PRODUCT CHANGE NOTIFICATION

Bourns® Model SM353230-181N7Y GbE Chip LAN Transformer

Core Design Change

SM353230-181N7Y

Dimensions of revised component

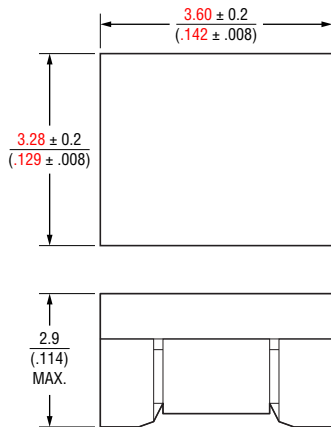
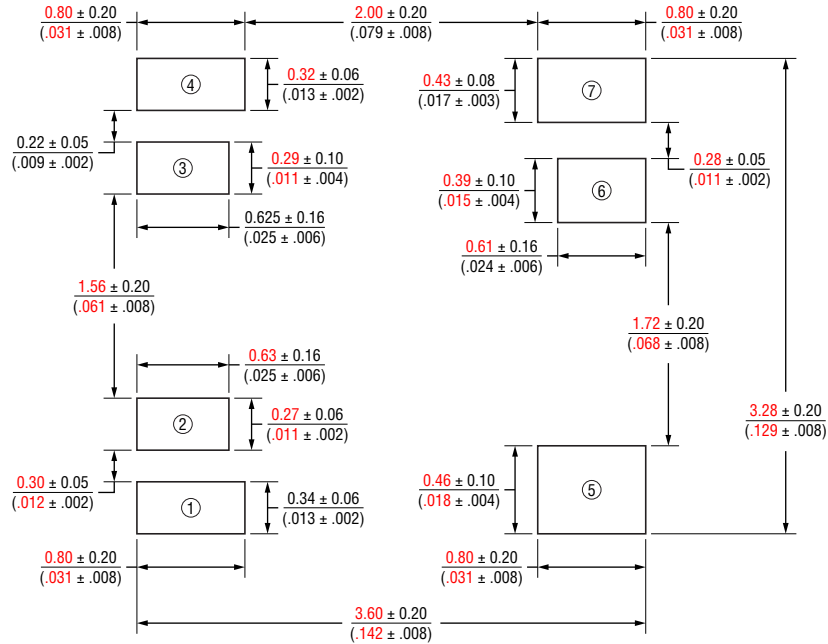
Riverside, California – August 3, 2021 – Effective October 16, 2021, Bourns will change the core design of the [Model SM353230-181N7Y GbE Chip LAN Transformer](#). The modified core size will be slightly larger which will enable higher withstanding voltage for the transformer.

The Recommended Layout remains unchanged. Although slightly larger, the modified transformer can be applied to the existing pad layout.

The form and fit of the transformer will be changed. The function remains the same. The quality and reliability of the component should be improved as a result of the design change.
